10-BSTD-01

October 13 and 14, 2011 Workshop - 2013 Building Energy Efficiency Standards

Again, thank you for the opportunity to comment on the draft fenestration criteria for nonresidential and highrise residential buildings. This is a follow-up to my previous comments submitted July 5, and testimony provided at the October 13 workshop.

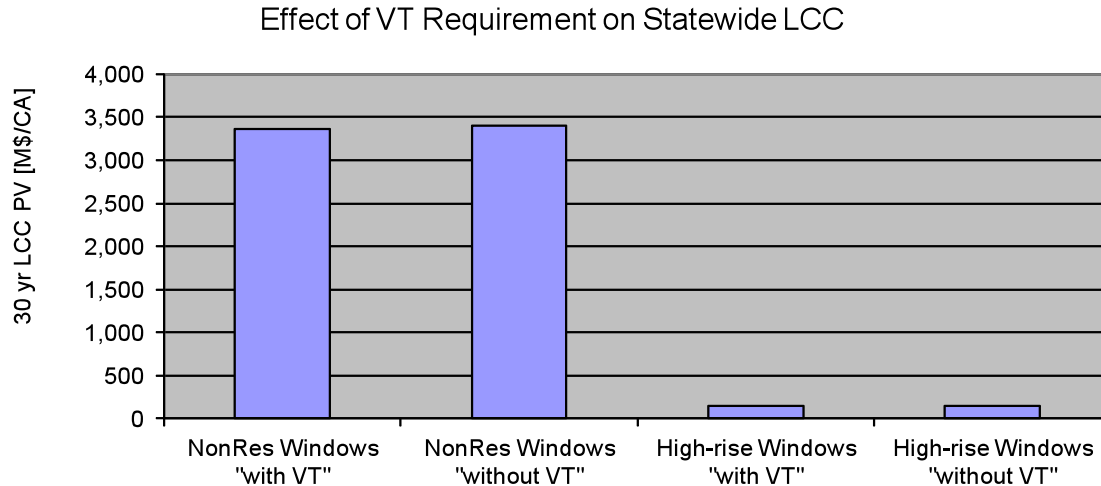
But first, it is useful to put the energy savings at stake into perspective. The CASE report assigns extreme significance to VT, but in fact, zooms in on very small changes in energy savings. Below is a plot of the TDV energy cost versus VT for the prototype office building using the correlation developed in the CASE study, but plotted to show the total value without zooming in:

It is apparent that the relationship between TDV energy cost and VT is actually rather flat, and the savings are quite small when put in context. Please don't misunderstand – *daylighting* energy savings can be significant, but daylighting is a lot more than just VT. Certainly, such a small change in energy savings over this large VT range does not justify picking one value or another as a new requirement, let alone eliminating 95% of the products shown in Figure 7-10 of the report.
